I PROJECT:	Wynot Public School Addition & Renovation	PROJECT NO.	L14208
FROM:	BVH Architects	DATE:	17 March 2016
TO:	All Bidders	ADDENDUM NO.	1

Wynot Public School Addition and Renovation
R.O. Youker, Inc. Project #16005
Addendum 1 Items
3/17/2016

addendum no. 1

B13/A5.2 WALL SECTION
1/2" = 1'-0"

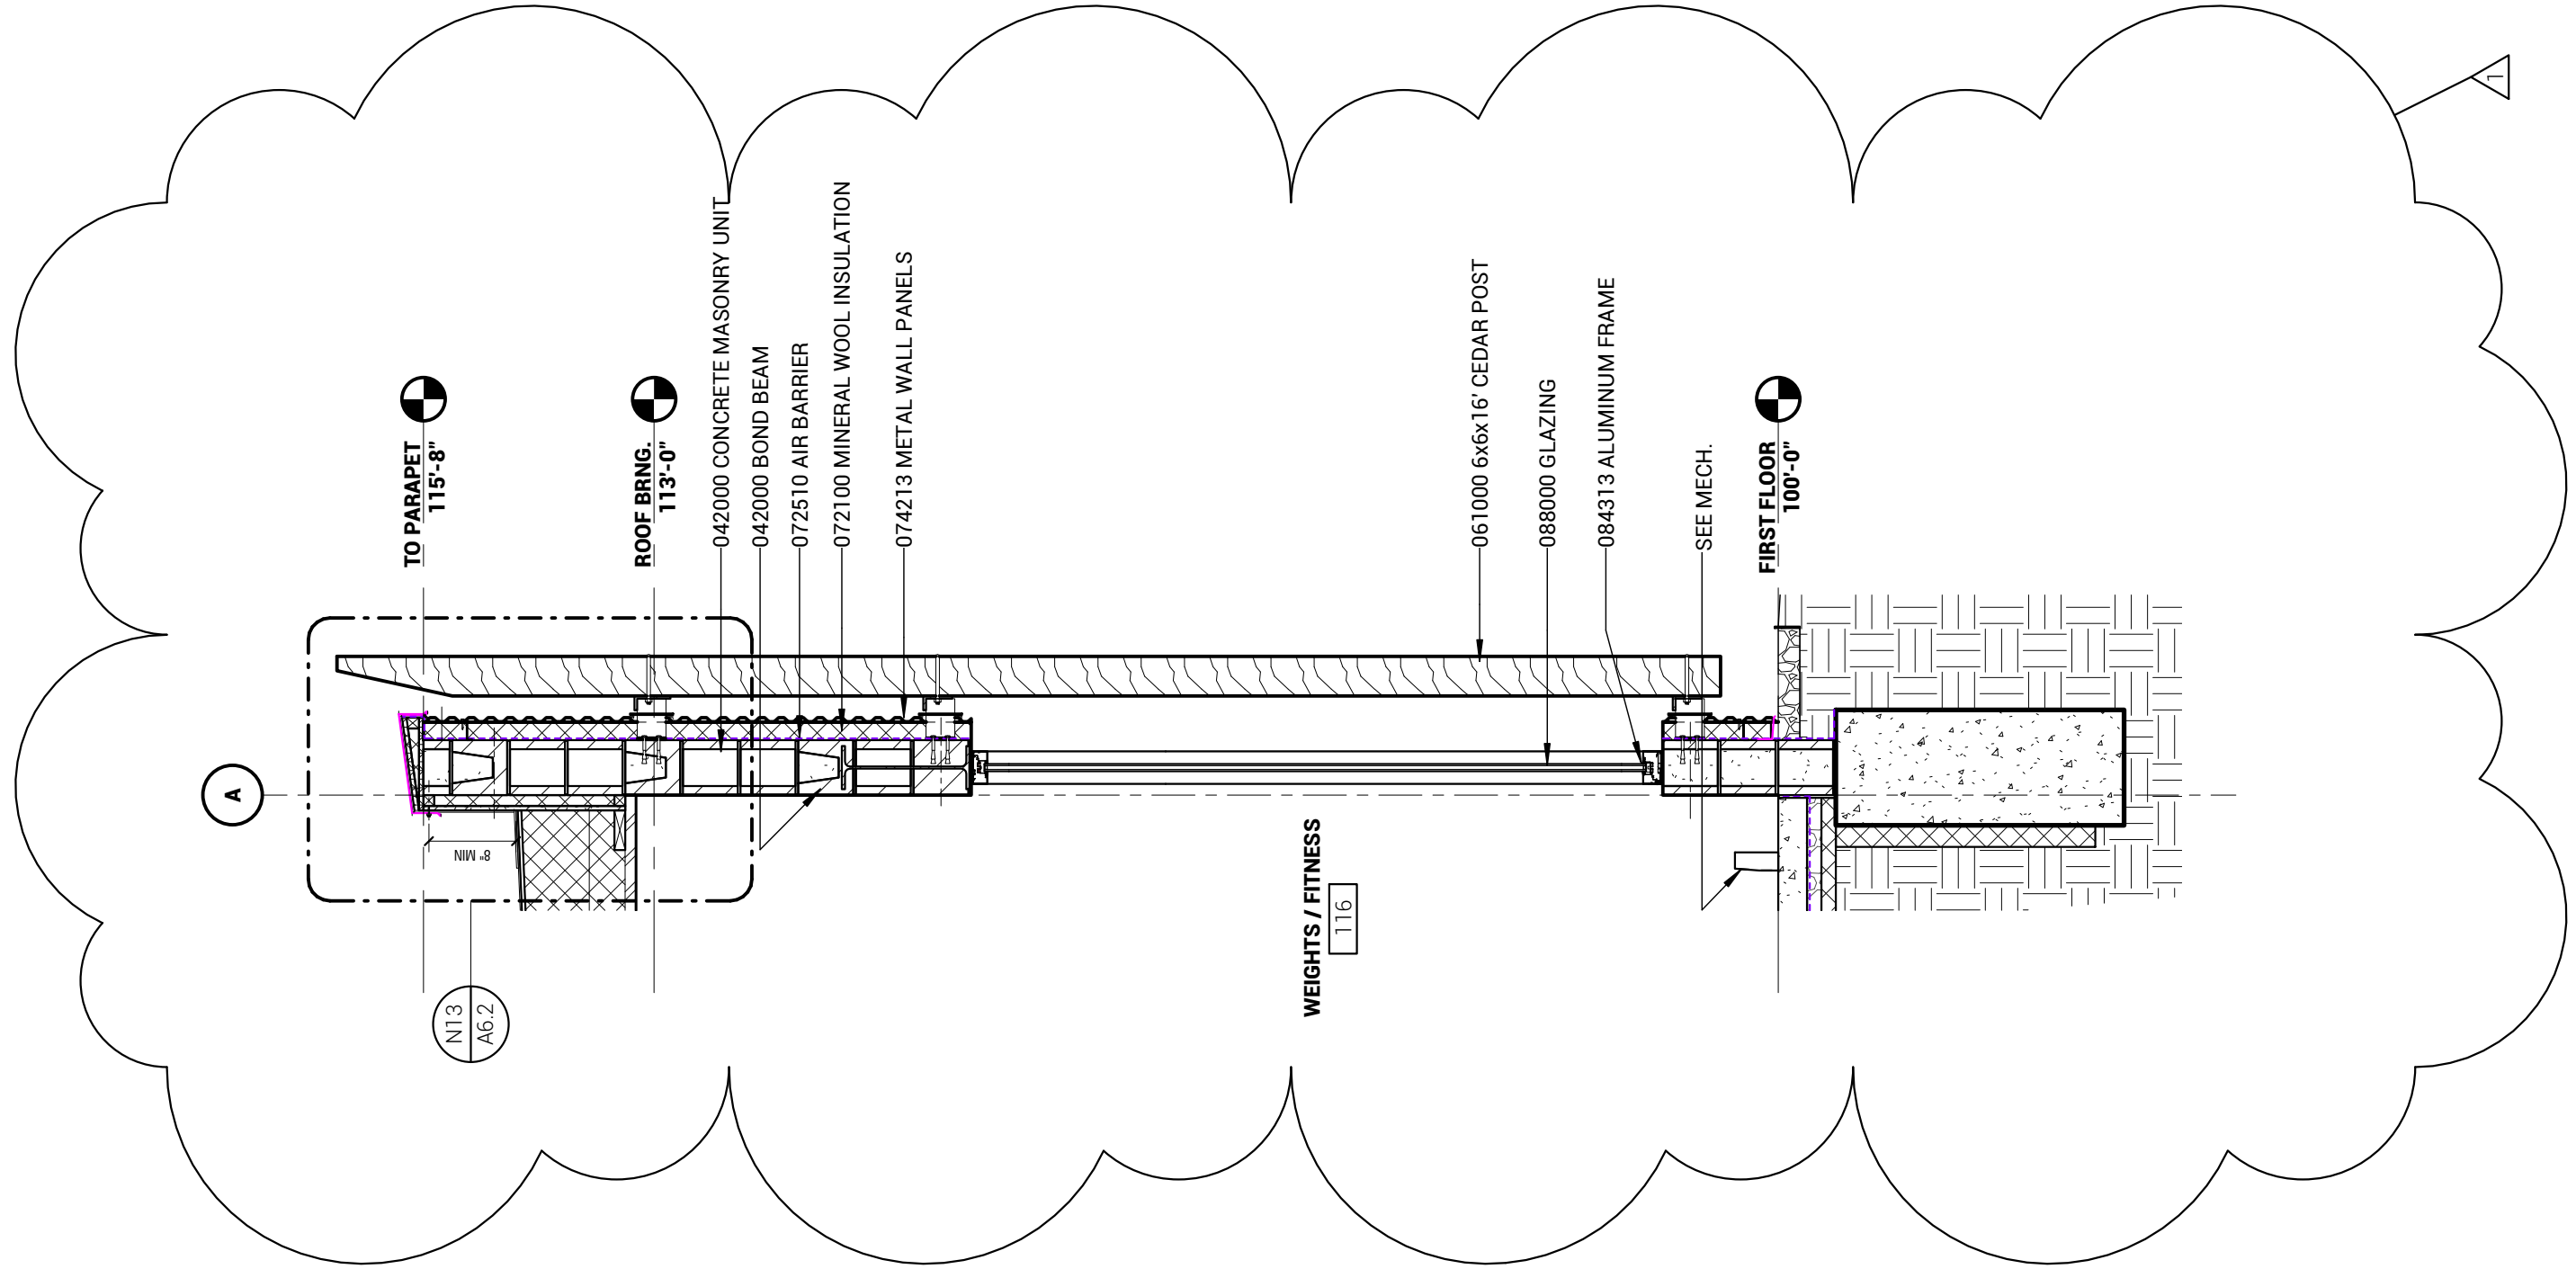
- b. Detail B13 (refer to attached Drawing 1)
 1. Window head and parapet revisions.
5. Sheet A5.3 Wall Sections (refer to re-issued sheet A5.3)
 - a. Typical casework sections added.

A1/A5.2 PLAN DETAIL
1 1/2" = 1'-0"

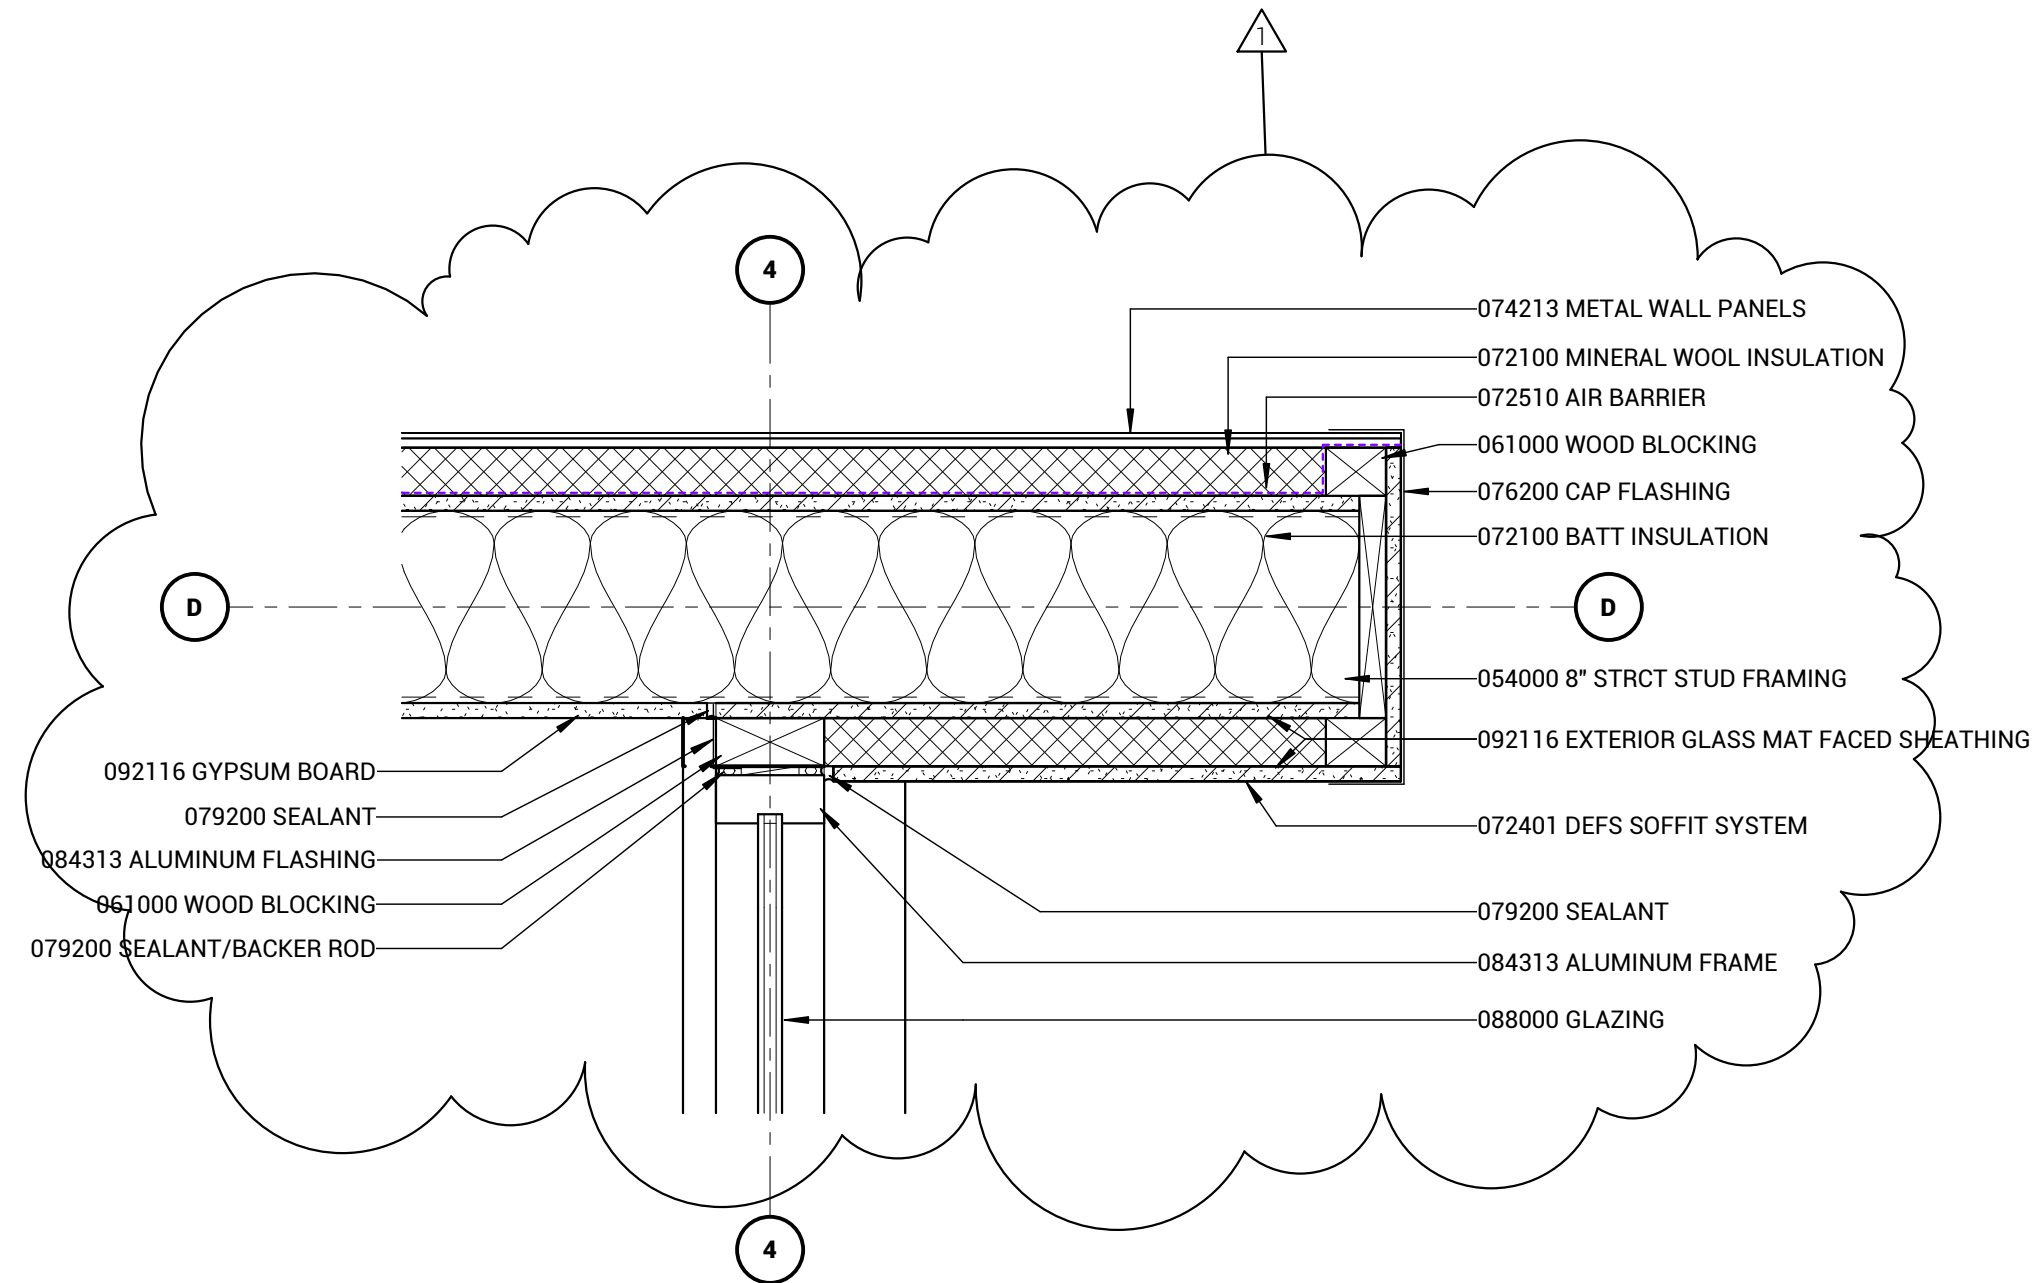
7. Sheet A6.1 Details
 - a. Detail H7
 1. Change HSS 3x4x5/16 tube to HSS 4x4x5/16.
 - b. Detail A1 (refer to attached Drawing 2)
 1. Add blocking for flashing installation.

C-2

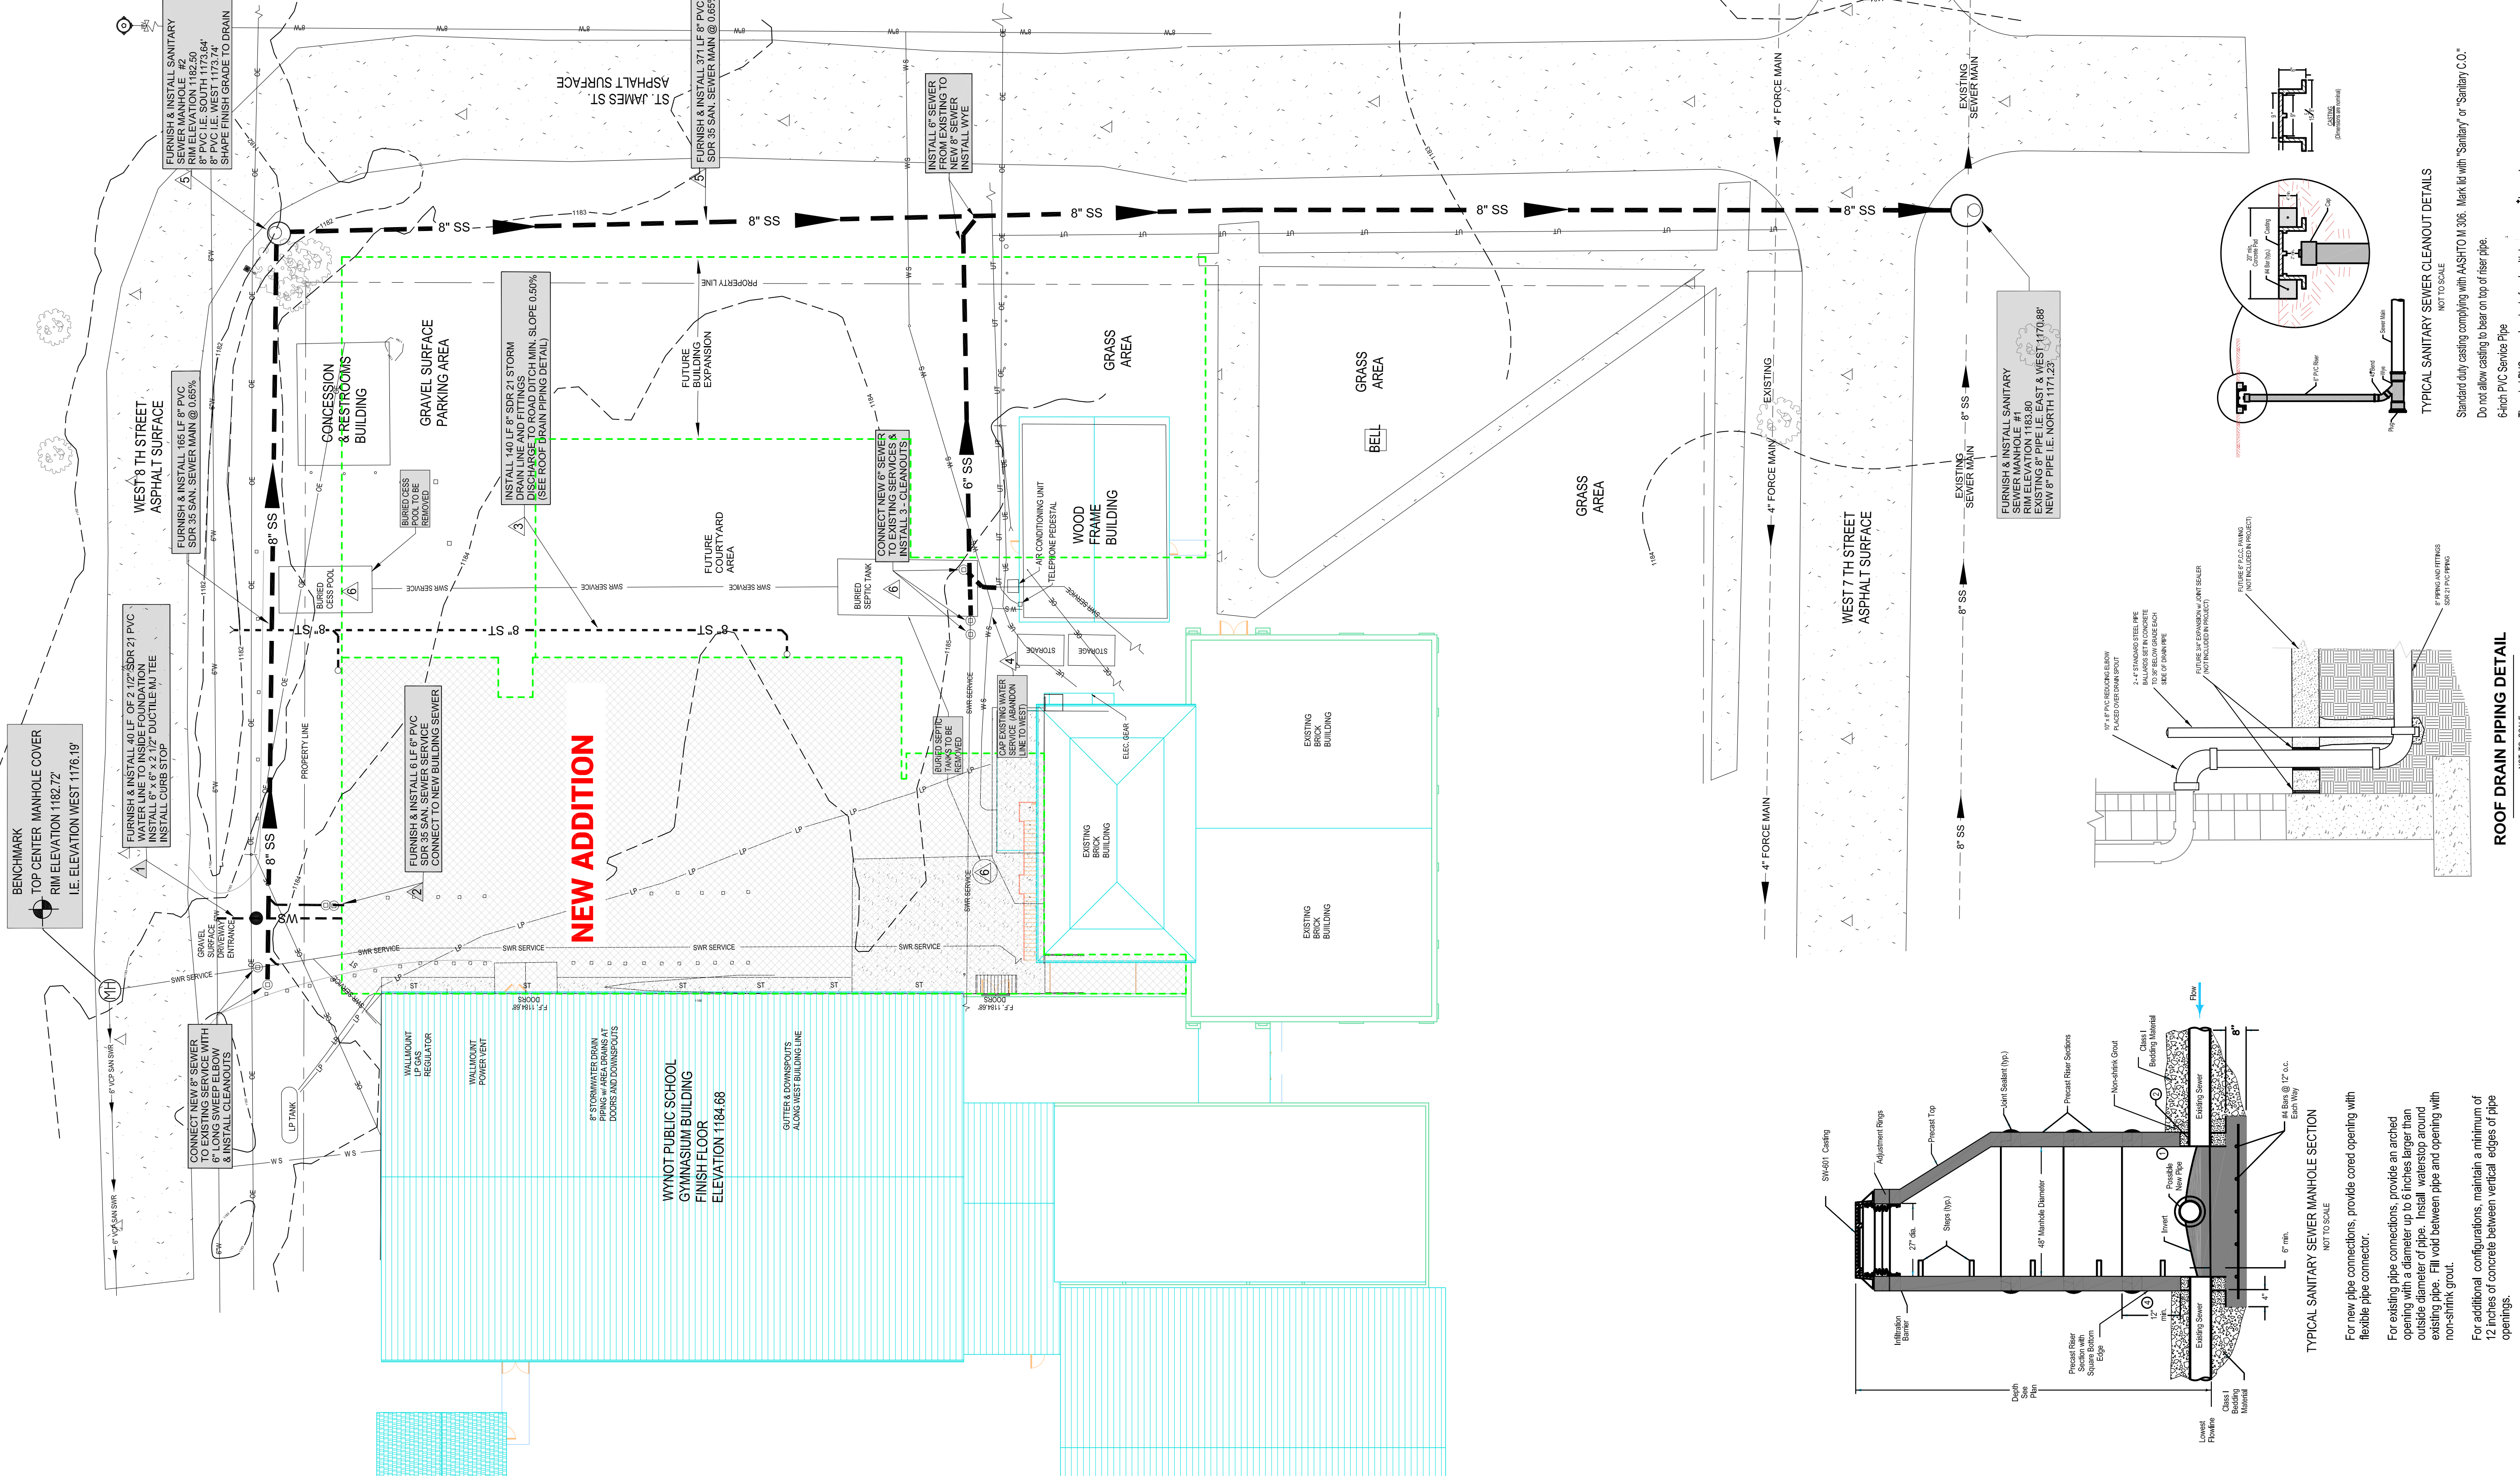
1. Sheet C-2 Utility Plan (refer to re-issued sheet C-2)
 - a. Street patching should be done with concrete in lieu of asphalt.
2. Sheet A0.1 Architectural Site Plan And Details (refer to re-issued sheet A0.1)
